Cory Decarbonisation Project

Written Representation on behalf of Landsul Limited and Munster Joinery (U.K.) Limited

Plant Layout Study

Figure 1 – Indicative Equipment Layout from DCO

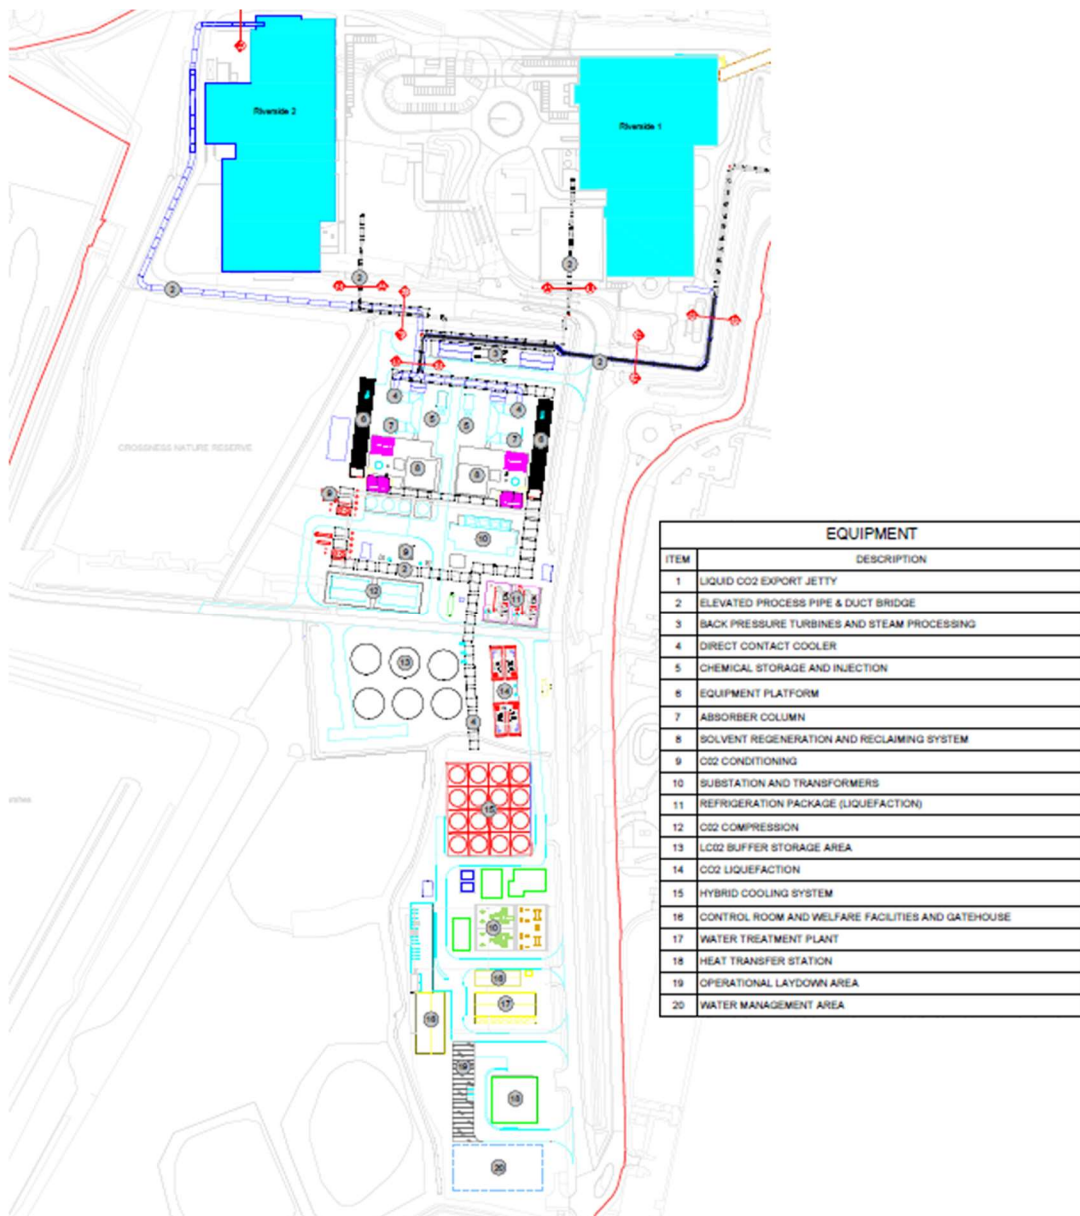
2.6 The equipment selected is generally typical of what would be expected for a facility to capture, liquefy and store CO₂. However, as I will explain in the following sections, there are some items of equipment that appear unnecessary and this, combined with some of the design assumptions, has led to a site footprint that is considerably larger than required.

2.23 In terms of the footprint occupied by this plant (items 3 to 8 in Figure 1) it is broadly in-line with what I would expect for a 2-line plant of this capacity.

Figure 2 - Footprint comparison (2 line vs 1 line)

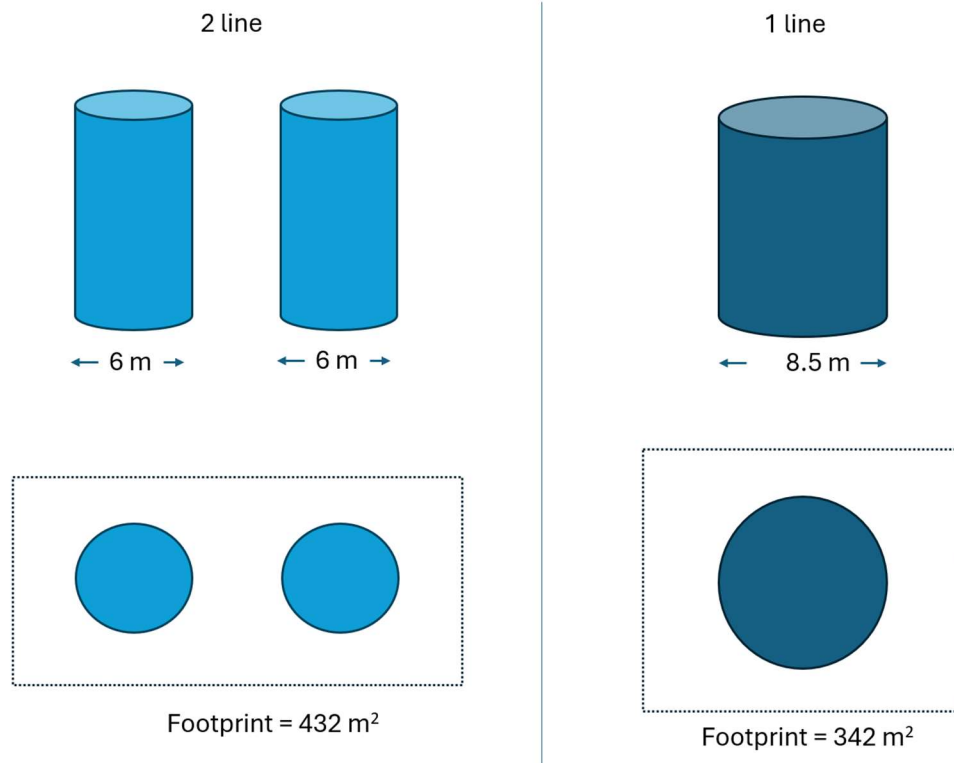
2.14 Finally, and most significantly, the overall site footprint is dictated not just by the process equipment itself but the need to provide access for operation and maintenance. Therefore, doubling the quantity of equipment also significantly increases the space that is required to permit operation and maintenance. This is illustrated by the simple sketch below which shows a 2 line plant utilising 2 x 6m diameter columns and the equivalent 1 line plant which would require a 8.5m diameter column to maintain the same column cross sectional area. For the sake of illustration, I have kept the height the same although (as per paragraph 2.13) this is not a hard constraint. For both, a 5m buffer around the units has been provided for maintenance. It can be seen that the footprint for the 1 line plant is 342 m² whilst the footprint for the 2 line plant is 432 m² (26% more).

2.15 It can be seen that the decision to adopt a two-line approach is not neutral in terms of footprint as the Applicant suggests. Rather, selecting a two-line approach will significantly increase the required footprint.

Figure 3 - "Substation and Transformers" equipment item from DCO application

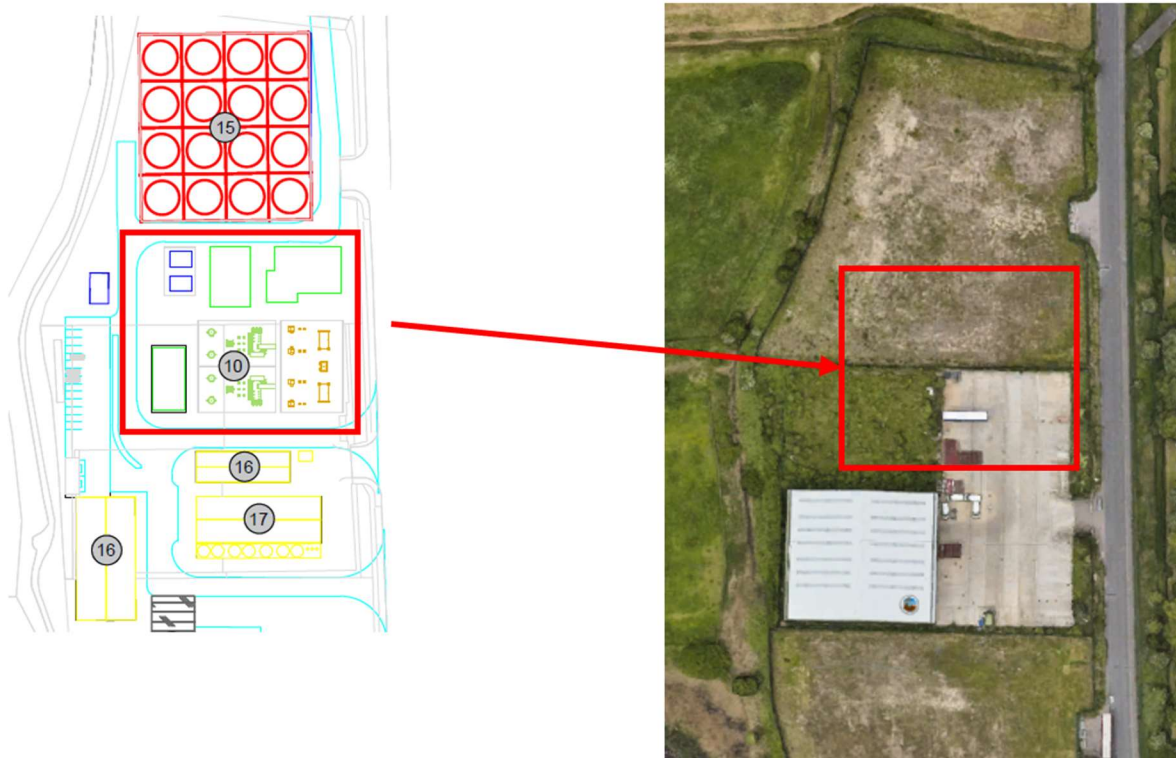
2.19 However, despite these arrangements the Applicant has also included a separate switchyard (item 10). This is shown in the diagram along with the approximate location on a satellite image from Google Earth.

2.20 Substation and transformer plant is used to provide appropriate isolations, metering and voltage step-up / step-down to connect facilities to electricity supplies on distribution and transmission electrical networks. In short, they enable electricity to be either imported or exported from a site. However, given that the Applicant proposes to serve the electrical needs of the development through a connection to the existing Riverside 1 and 2 facilities plus self-generation through a back-pressure steam turbine generator unit the need for this substation and transformer plant is not apparent.

2.21 The area of the red box in figure 3 is approximately 0.4 hectares (4,000 m²). This is equivalent to about half of the Munster Joinery Land.

Figure 5 - Liquefaction and Storage (items 11, 13 and 14)

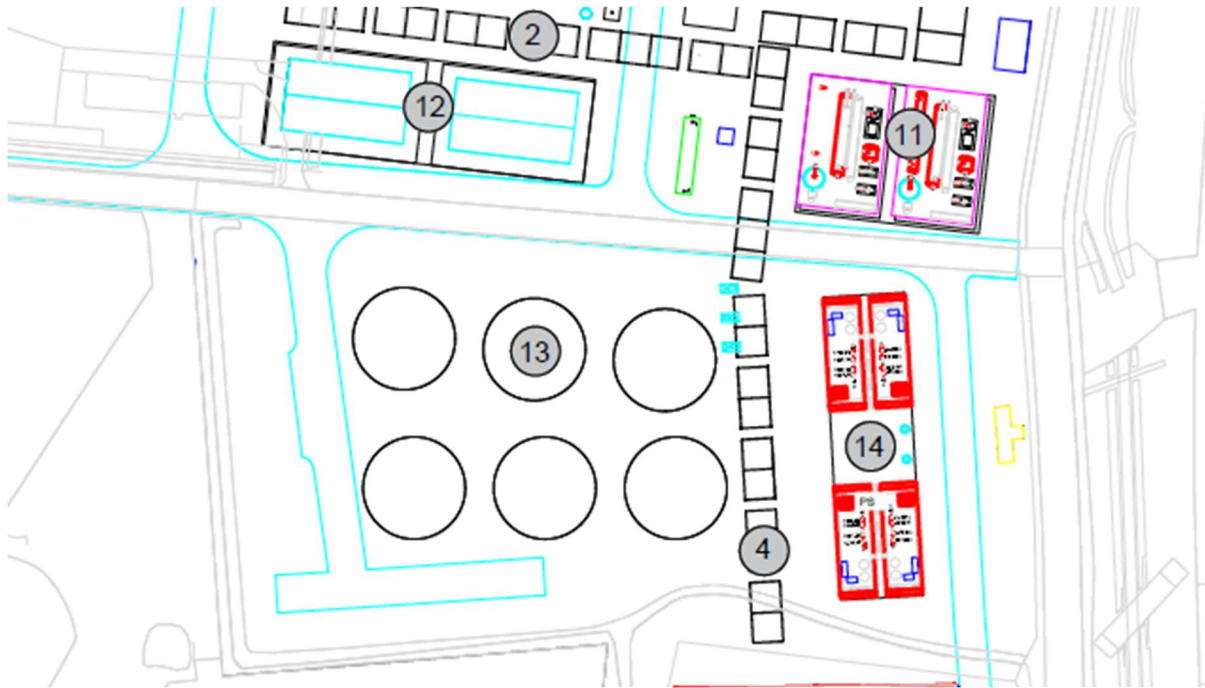
- 2.28 The area of land occupied by the liquefaction and storage is approximately 11,250 m². However, it can be seen from Figure 5 that the actual process equipment occupies less than half of this. As I discuss in 3.8 to 3.9 it is possible to accommodate liquefaction and storage equipment that will achieve the required duty in a much reduced space without compromising operability and maintainability.

Figure 6- Heat transfer station and operational laydown area

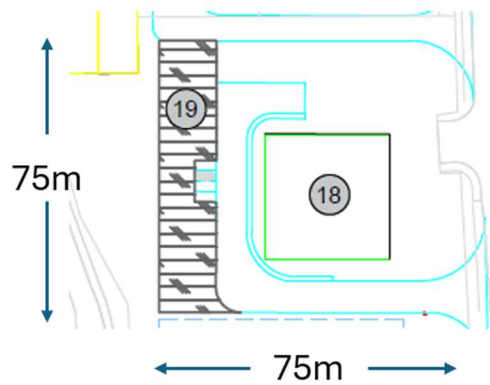
- 2.48 A feature of the Applicant’s layout is the significant space that is allowed around items of equipment and a failure to best optimise the footprint available. The heat transfer station is an example of this as can be seen from Figure 6 below. The heat transfer station is designated 18 whilst area 19 is designated for operational laydown. It can be seen that the heat transfer station is surrounded by roads and hardstanding meaning that the building itself occupies only about 25% of the available area to the east of the operational laydown area. Access to the operational laydown area is achieved from a road running between that area and the heat transfer station ignoring the potential to use the area to the west of the operational laydown area for access which means that area is effectively unused.

- 2.49 As shown in Figure 6 the Applicant has configured the site such that there is an area allocated for operational laydown. Operational laydown, in relatively close proximity to the plant is certainly beneficial – particularly during outages. However, there is no absolute requirement that this be on the carbon capture site itself – it could be located within the wider Riverside campus. It would appear that there is plenty of other alternative land available to the Applicant for temporary laydown on the existing EfW facilities as shown in the image from Google Earth below.

Figure 11 - Options considered by the Applicant

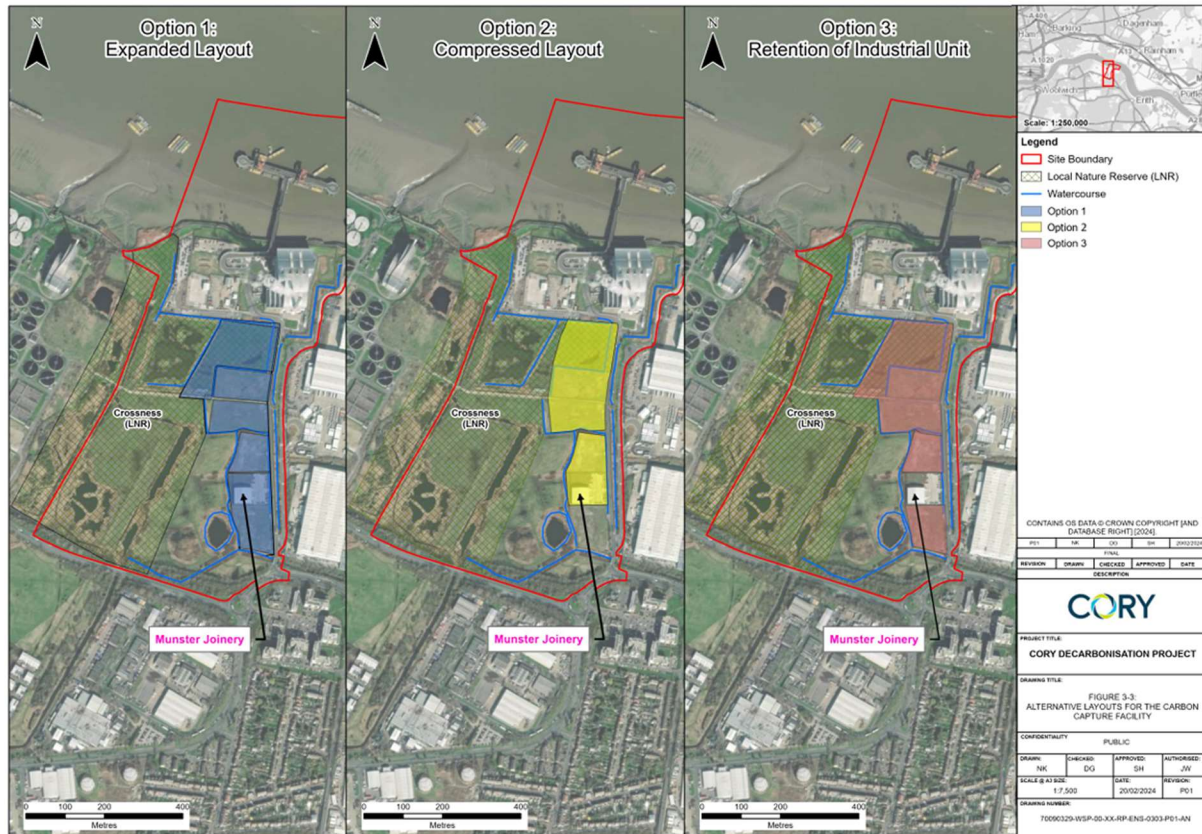
4.2 The Applicant states the required footprint to be approximately 8 hectares (80,000 m²)^[16]. As shown in Figure 11 the Applicant provides a footprint^[19] for three different potential layouts.

4.3 As a comparison, I have measured the total footprints of the Applicant’s options and my alternative layout using Google Earth. The comparative approximate footprints are:

Figure 13- Footprint reduction opportunities

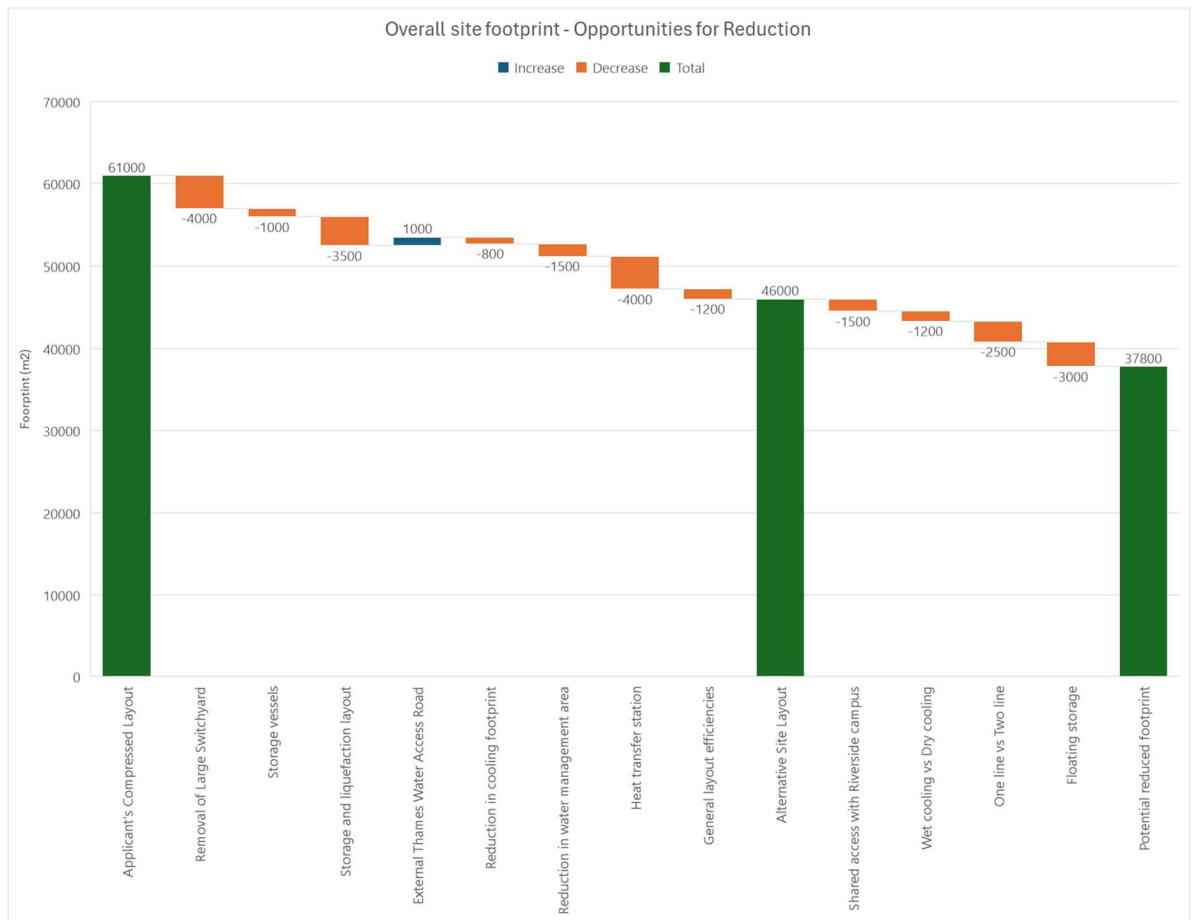
- 4.7 In addition to the savings identified in the Alternative Layout, the waterfall chart also makes some estimates on additional savings that might be attainable if different design assumptions / decisions were taken.

- 4.8 As can be seen from Figure 13, one area of footprint saving is simply being more efficient with the specific location / position of plant items and supporting infrastructure (in particular for the liquefaction and storage plant). This is partly due to the shape of the land for the development. For the southern part especially, it is not a rectangle / square which makes it harder to fully utilise the land available in that part of the site. Further, given that provision of access around plant and equipment is a significant driver of required footprint, reduction in equipment sizing (for instance the CO₂ storage vessels) also enables a reduction in footprint for access.

Figure 17- North 1 Zone available footprint

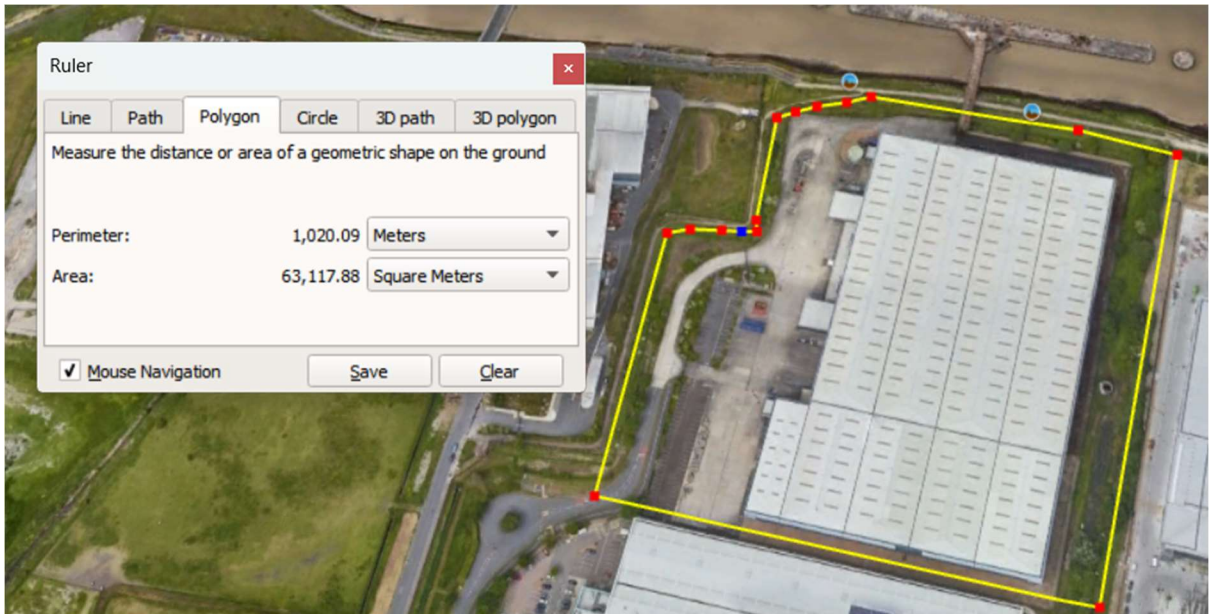
- 4.18 I would also note that in terms of business impact, the area that is actually required for the development is very much smaller than the East zone considered. As shown in Figure 17 below, the terrestrial part of the area now designated as North 1 by the Applicant is sufficiently large to accommodate the full carbon capture development even using the 61,000 m² footprint of the Applicant’s own proposed scheme. The result of this is that there would be no impact on the Lidl operation as assumed in the assessment of the East Zone in the Terrestrial Site Alternatives Report.
